REMARKS/ARGUMENTS

Application Serial No. 10/667,838
Reply to Office Action of August 8, 2006

**Replacement Sheet of FIGS. 5 and 6
(a total of 1 sheet of drawings)**

FIG. 5

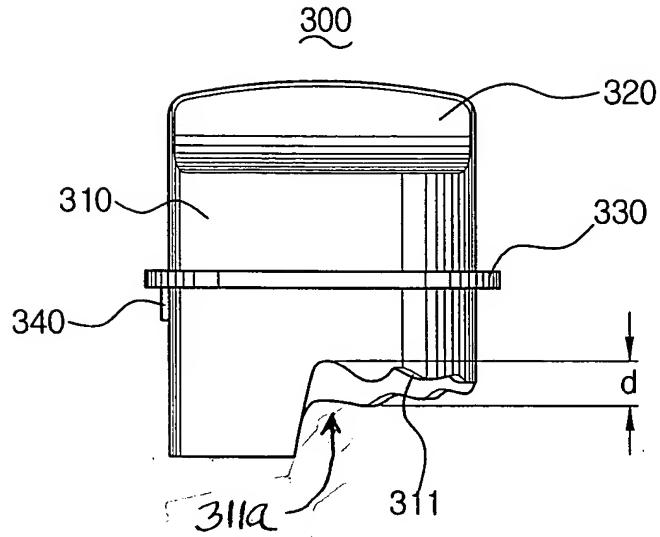
The attached drawing sheets include changes to FIGS. 5 and 6. These sheets contain corrections highlighted in pink for the examiner's approval and are requested to replace the original sheet of FIGS. 5 and 6.

3. The drawings were also objected to because they did not include a reference numeral "311a" which is used in the specification to identify grooves in the height adjusting knob. In response, the Applicant has submitted herewith a replacement sheet for Fig. 5 and Fig. 6, and an annotated sheet showing the changes to Fig. 5 and Fig. 6. The Examiner will note that reference numeral "311a" has been added to both of these figures and this reference numeral identifies the grooves in the rotatable height adjusting knob.
